REVIEW OF PLANS AND SPECIFICATIONS

PROJECT: Town of Medicine Bow  
Laramie, WY - Albany County

WATER QUALITY DIVISION REFERENCE NUMBER: 78-501

ACTION: NOT AUTHORIZED FOR CONSTRUCTION

## Exhibit 1

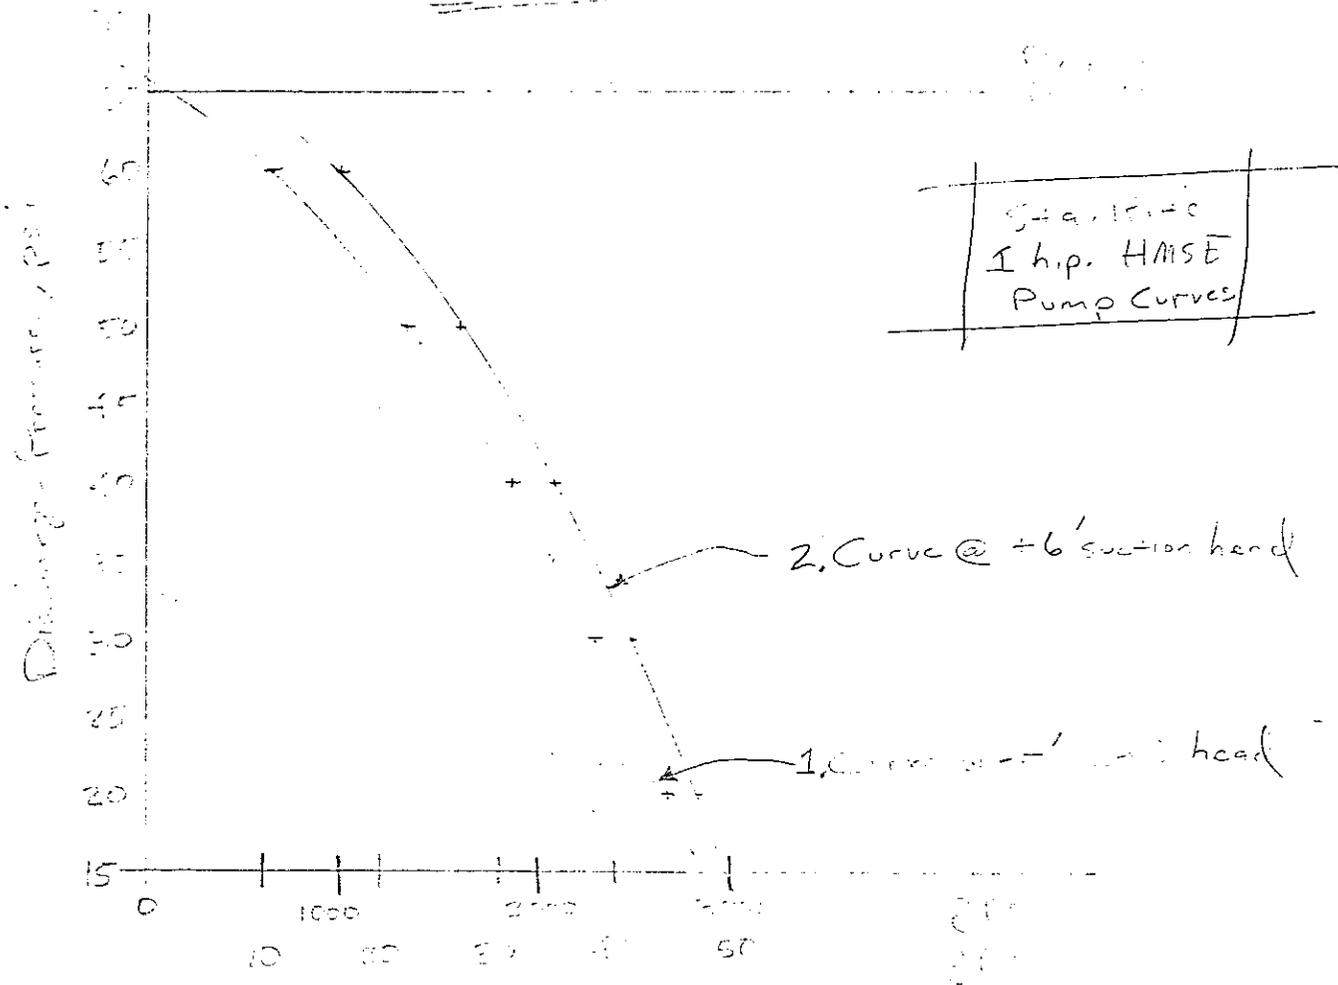
During those parts of the day when demand is running 8 gpm or less, there may likely be problems with excessive cycling of the pump. In discussing why this is so, reference will be made to Exhibit 1 which shows pump curves for the proposed 1 h.p. Sta-Rite Corp HMSE pump. As explained in the Exhibit, it is felt that Curve 2 better represents the proposed pump set-up.

At a demand of 7 gpm (slightly above average) in the system, the discharge pressure for the booster pump will rise to about 65 psi (see Exhibit 1, Curve 2), the specified shut-off pressure for the pump. At this point the system will ride on the pressure tank until pressure drops to 30-40 psi, at which time the pump will kick back on. Between 65 and 30 psi the storage in the tank can be expected to be only 40-50 gallons, thus supplying water for only 6-7 minutes. When the pump comes back on, it will be pumping in the 30-40 psi range @ a rate of 30-40 gpm. The tank will fill up quickly, and the 65 psi shut-off pressure will soon be reached.

Therefore, during demand periods of 7 gpm or less, frequent cycling can be expected. And as shown in Exhibit 2, there can be long periods of the day when flow will hang around the daily average.

Your options in this matter include providing a tank of 200 gallons or larger, or providing oversized, continuously running pumps that will recirculate into the storage tank during low demand periods to prevent pump overheating (Recirculation also helps prevent tank freezing in winter.)
